Impact Assessment Agency of Canada

DECEMBER 2022

LNG Canada Development Inc. (the proponent) proposed the construction and operation of the LNG Canada Export Terminal Project (the Project), a natural gas liquefaction facility and marine terminal for the export of liquefied natural gas (LNG) in the District of Kitimat, British Columbia (B.C.). The Project would convert natural gas to LNG, approximately 26 million tonnes per annum, for export to global markets. The Project is expected to have a life of at least 25 years. The Project began construction in 2015.

On April 1, 2022 the proponent informed the Impact Assessment Agency of Canada (the Agency) of changes to the Project design to include the construction of a tug berth facility at the existing non-operational jetty and the construction of a diesel and LNG bunkering area at the northeast corner of the materials offloading facility (Figure 1). The proponent's amendment assessment can be found here: LNG Canada Export Terminal Project-Canada.ca (iaac-aeic.gc.ca). The proponent described the changes, the potential effects of the changes to valued components of the environment, and a summary of engagement with Indigenous groups re

Figure 1 – Site Map

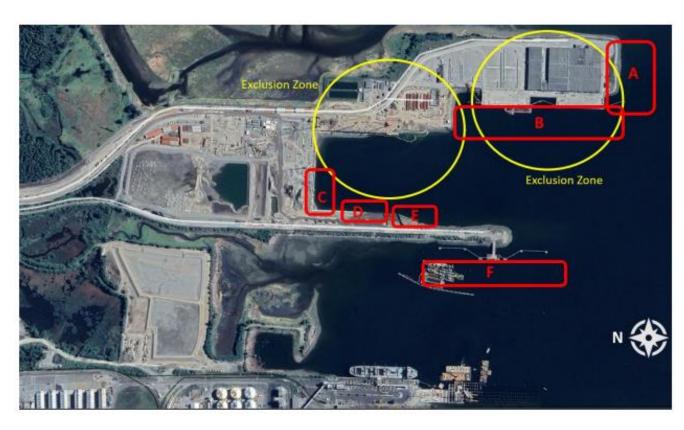
The proponent has requested a change to the Certified Project Area in the province's Certified Project Description to authorize the construction and use of a tug berth facility that accommodates six chartered tugs, i.e. small marine vessels used for escorting, towing and pushing of LNG Carriers that will operate around the Project site. Three tugs would be used to escort LNG Carriers and three tugs would be used in the harbour to assist the LNG Carriers specifically with docking and undocking. The Certified Project Area would require expansion to include the new facility (Figure 1 – Site Map).

The proponent intends to construct a diesel and LNG bunkering area located at the north-east corner of the Materials Offloading Facility (MOF), which is currently under construction (Figure 1). Diesel would be brought in by truck and transferred directly to the tugs. LNG would be transferred onto LNG carriers for use as fuel through installation of additional pipework on the wharf.
